### **Plan Change 60 - Maxwell Hills Zone – Reply to Request for Further Information**

**RESPONSE TO REQUEST FOR  
FURTHER INFORMATION  
RESOURCE CONSENT  
APPLICATION  
PLAN CHANGE 60 - MAXWELL  
HILLS ZONE**

The following responses, prepared by Riley Consultants Ltd (RILEY), relate to questions raised by Mr Paul Whyte of Beca Carter Hollings & Ferner Ltd (Beca) on behalf of the Marlborough District Council (MDC), in their letter dated 10 June 2011, requesting further information.

Project No	Sheet	Revision
009025	130	B

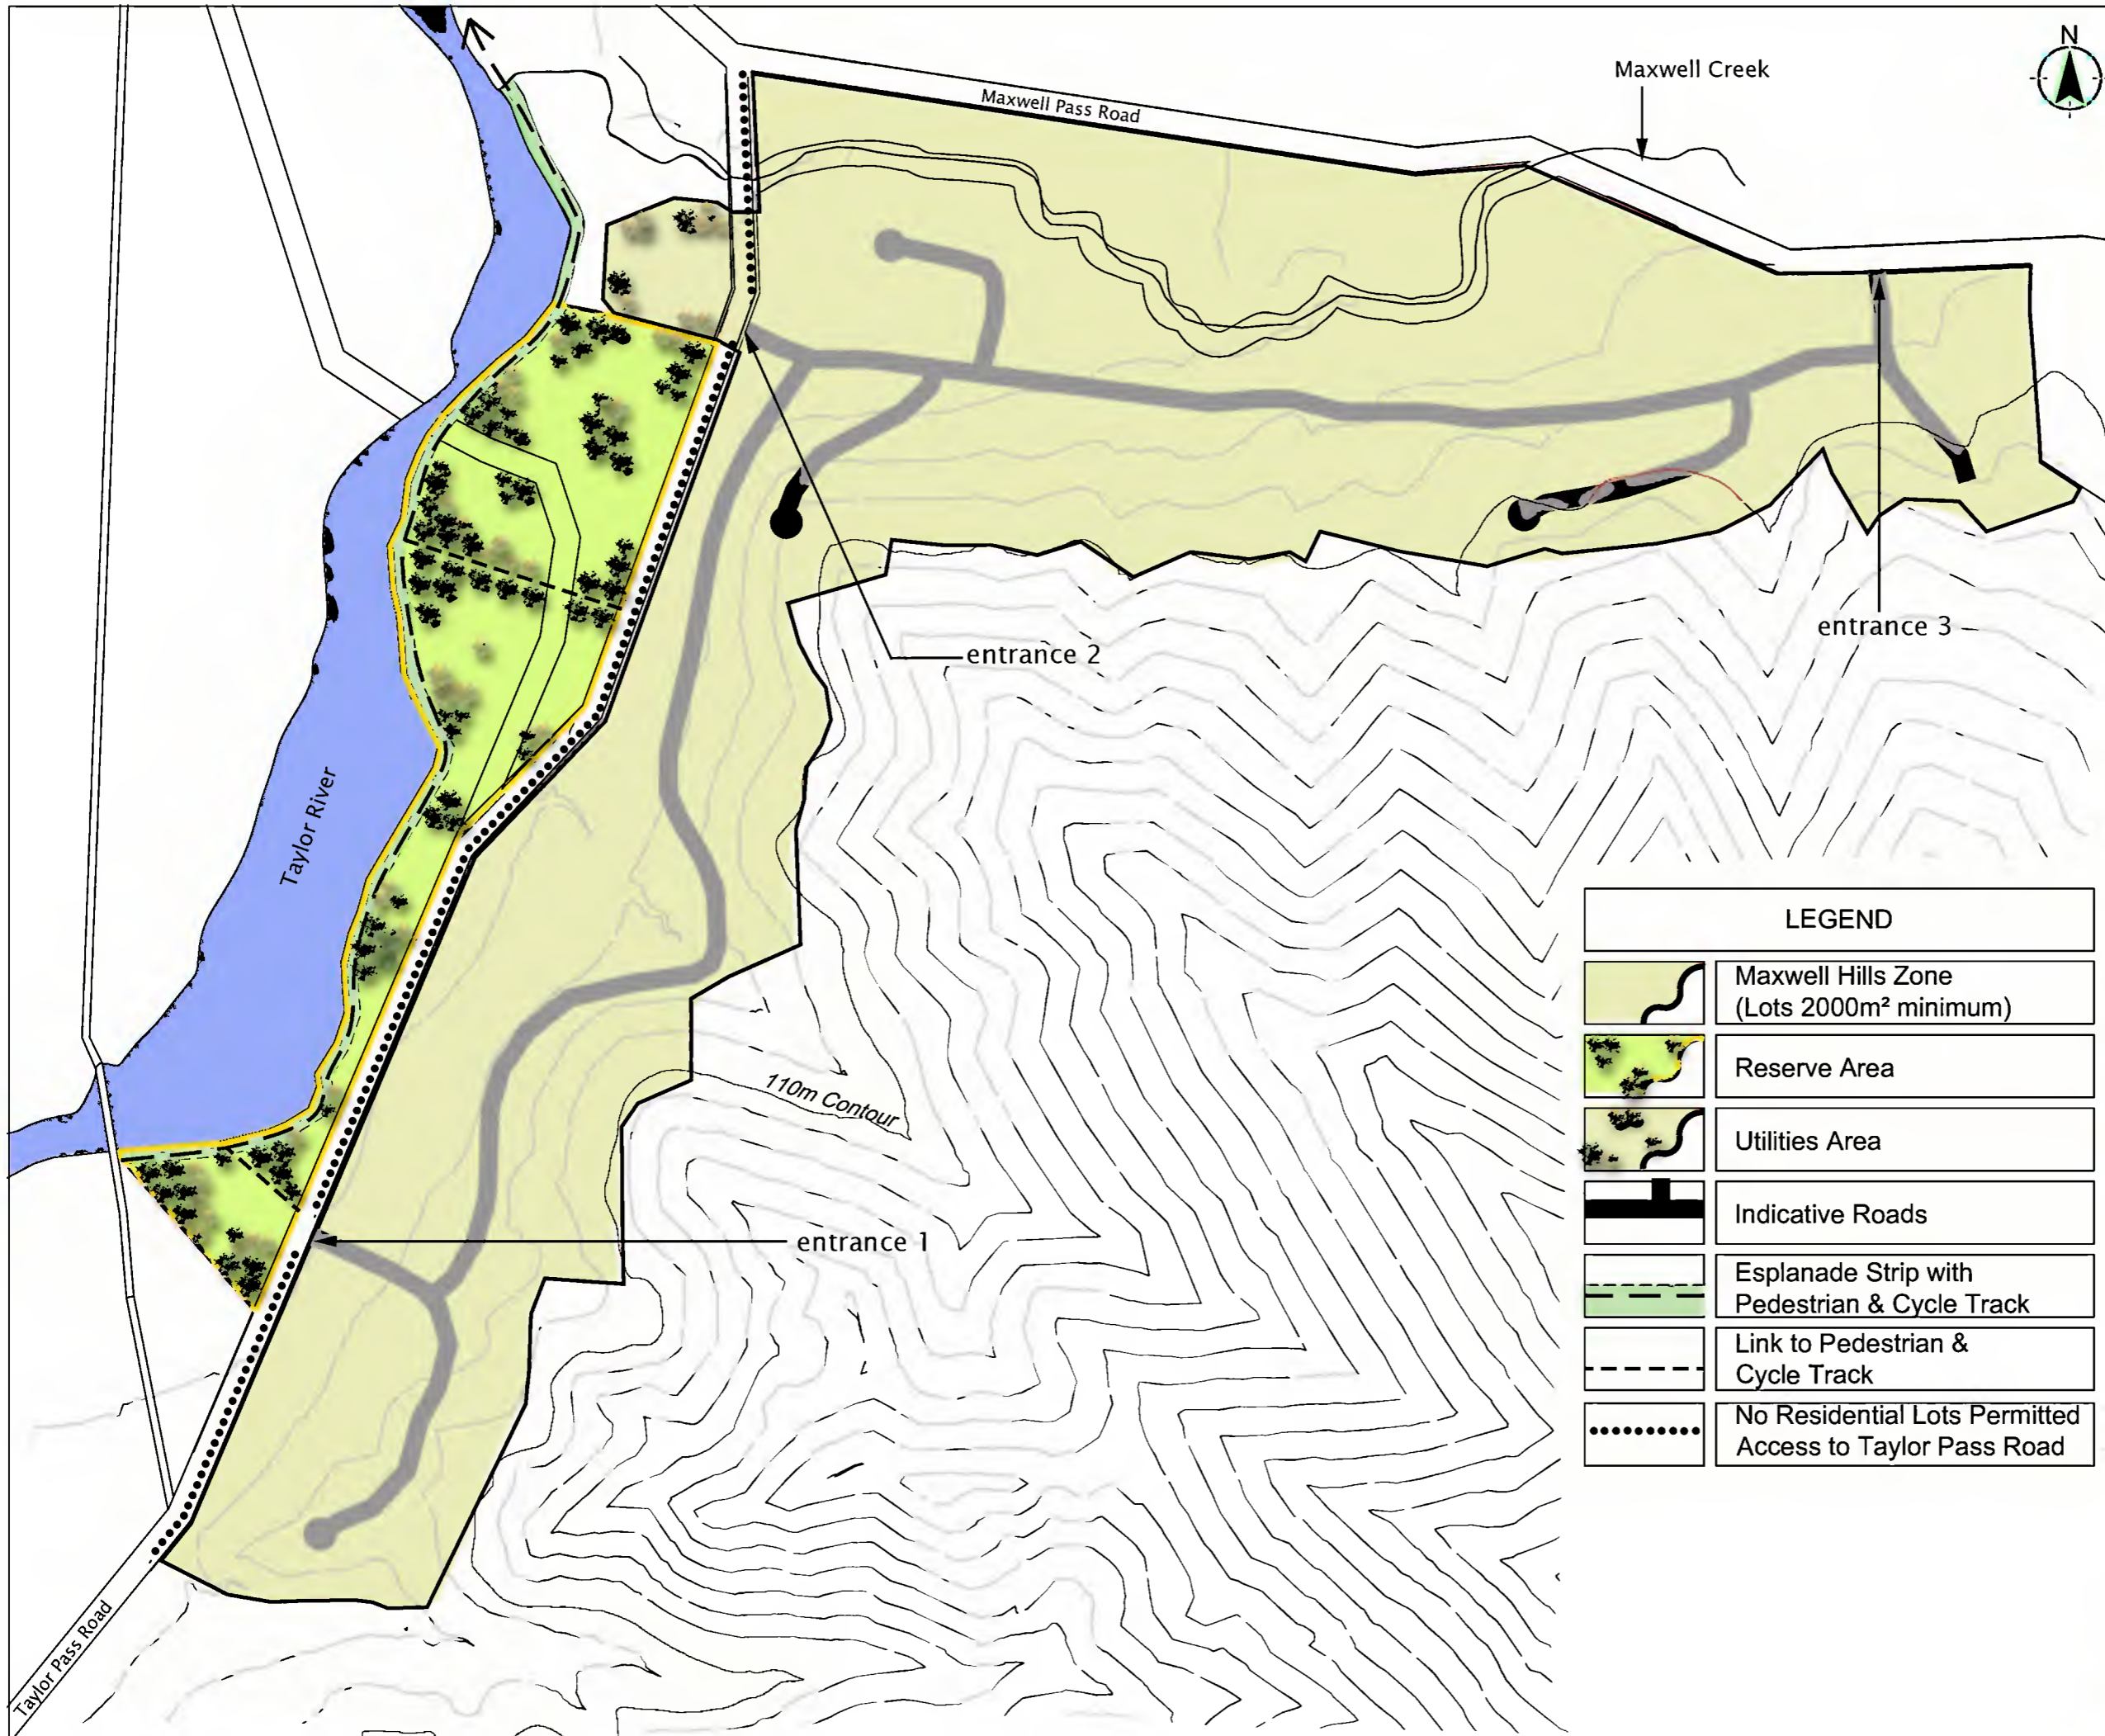
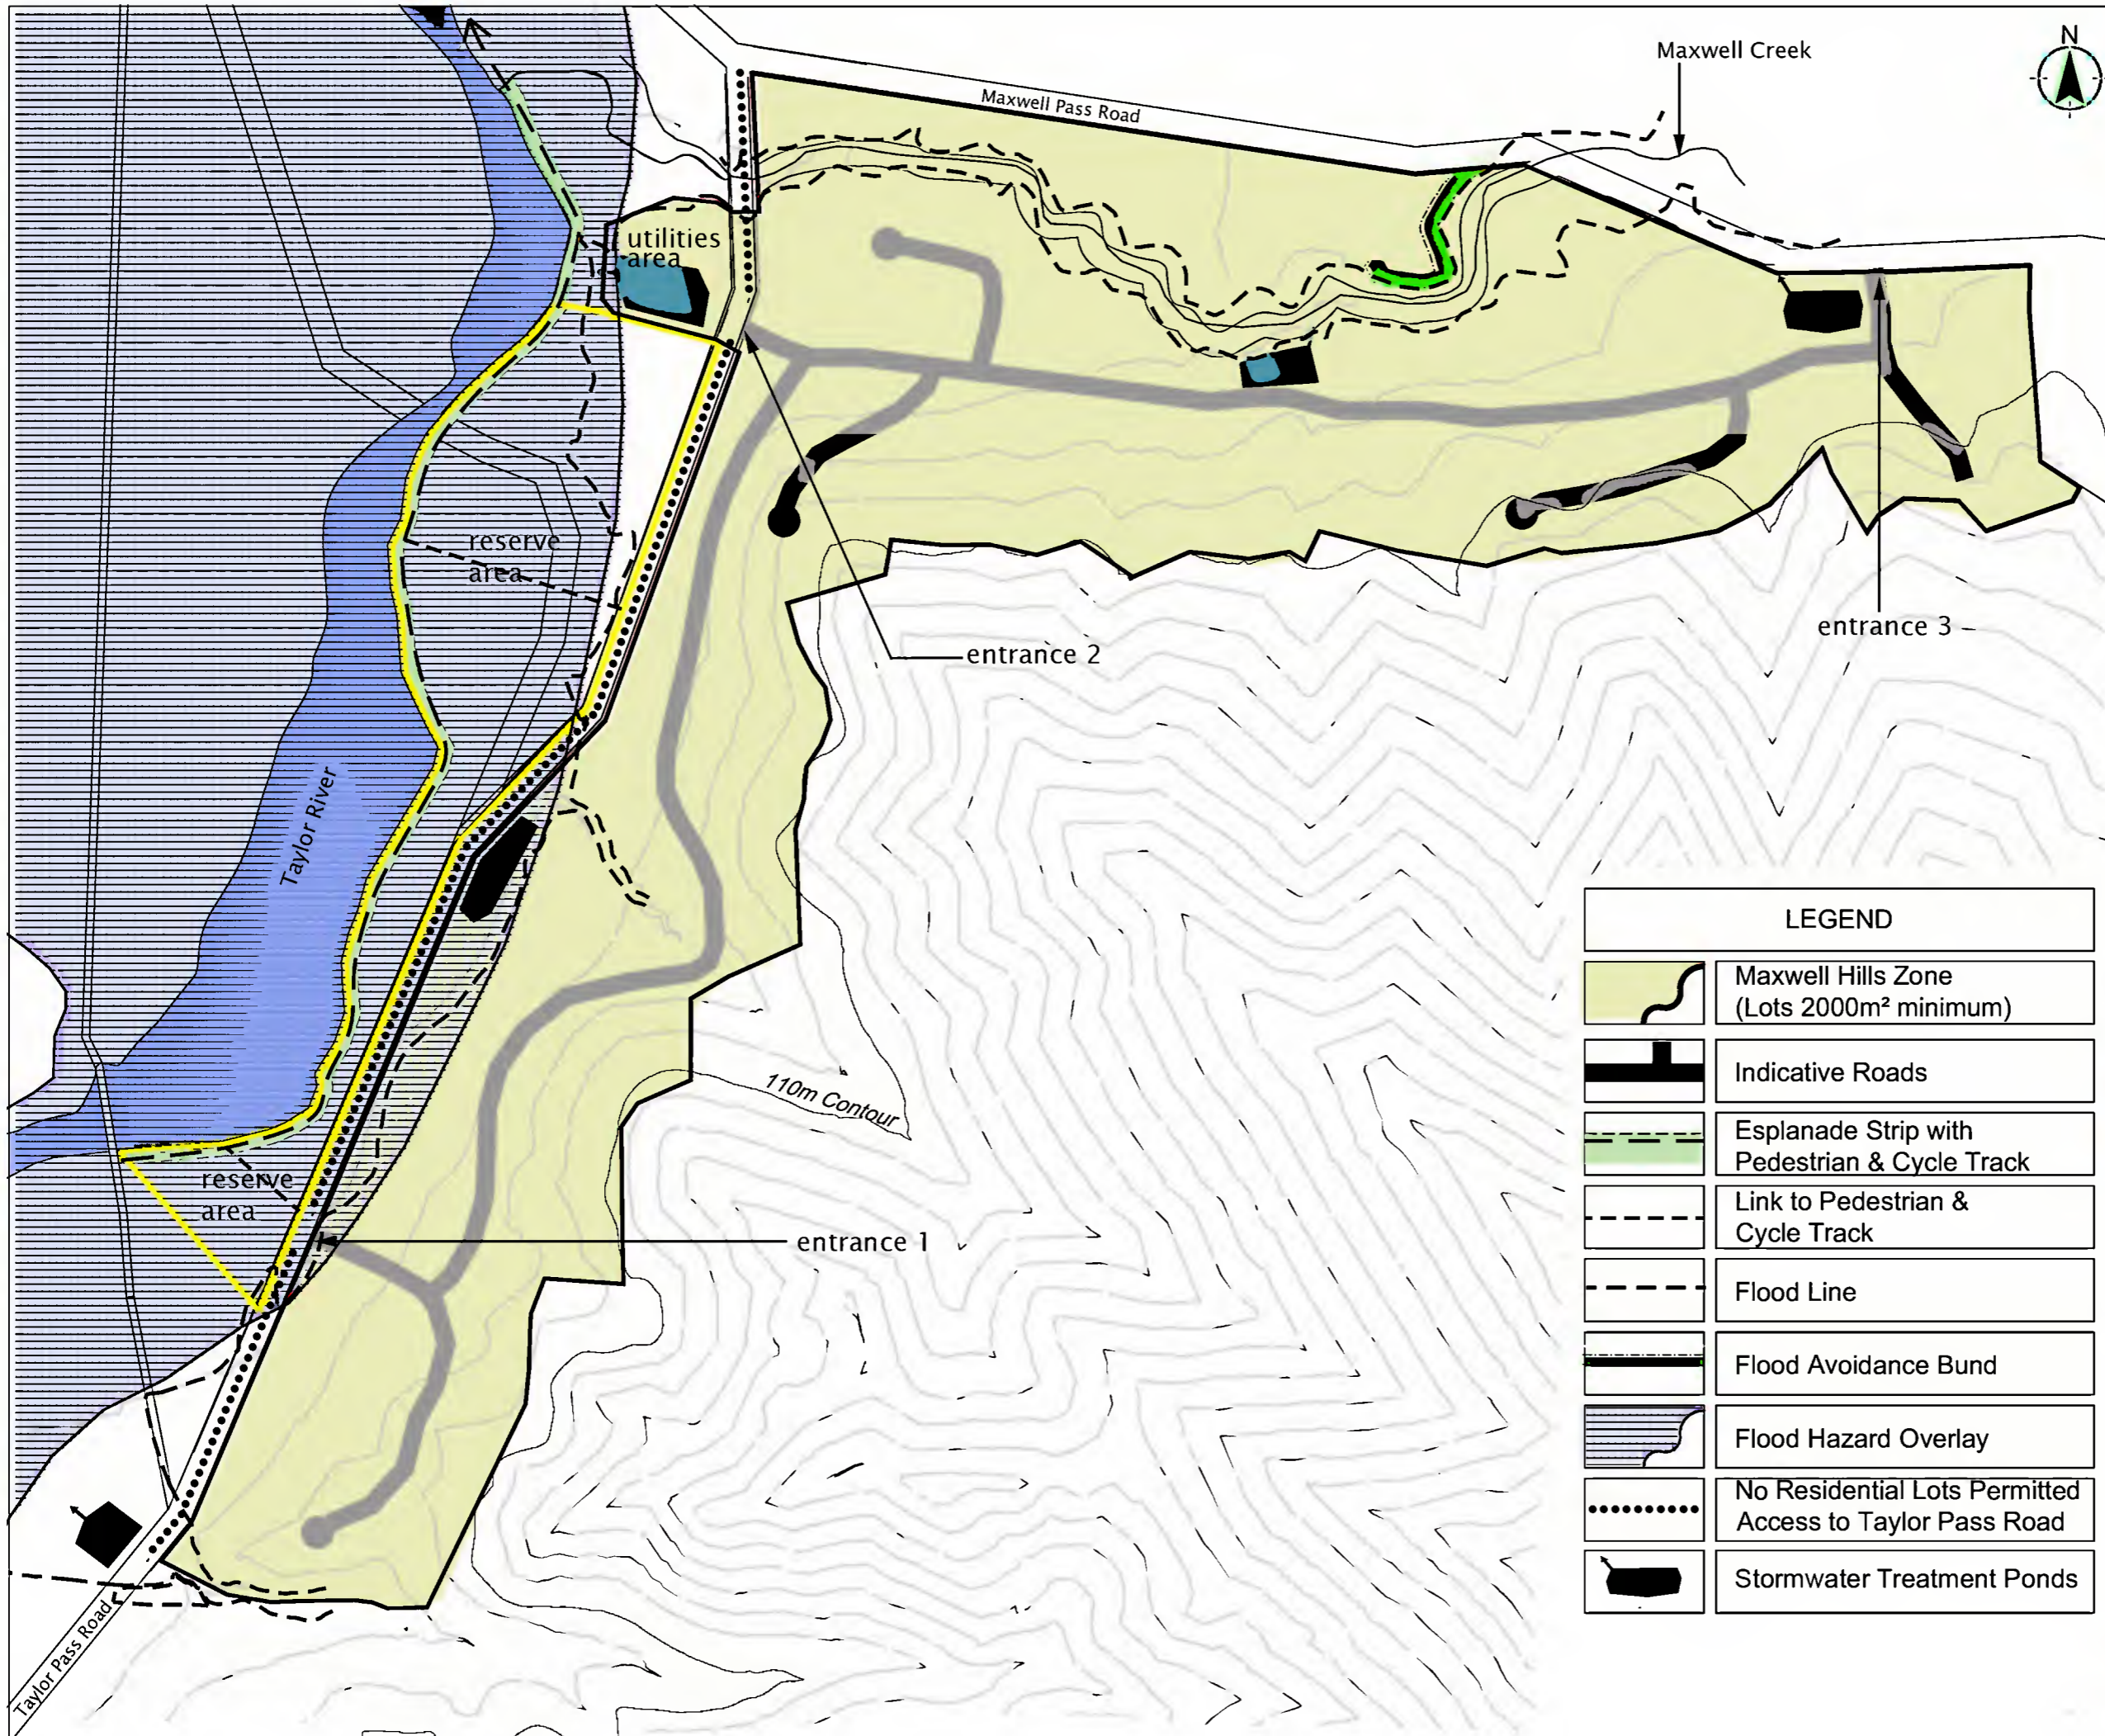
4. *Rule 2.2.6.1.3* – A revised Outline Development Plan is attached (Appendix V) which more clearly shows the flood hazard overlay.
5. *Hazards Register* – the Hazards Register is referred to elsewhere in the Plan (see for example Rules 31.1.6.2 and 32.1.5.2). However, if the Council no longer maintains a hazards register we see no reason to refer to one. Please find attached the revised Schedule of Changes (Appendix V). We have deleted the note referring to a hazards register.

12. A decision was made to not include the conceptual layout of lots as shown on the Riley Stormwater Report. The stormwater layout was primarily to show what was feasible and how a potential development could be serviced. During subdivision consenting, specific easements for stormwater will be required to be included as per clause 29.2.12 and clause 28.2.5. Given the nature of the topography, these easements will affect the location of the final lot boundaries. However, it is noted that the stormwater ponds have been included in the revised Outline Development Plan (Appendix V).
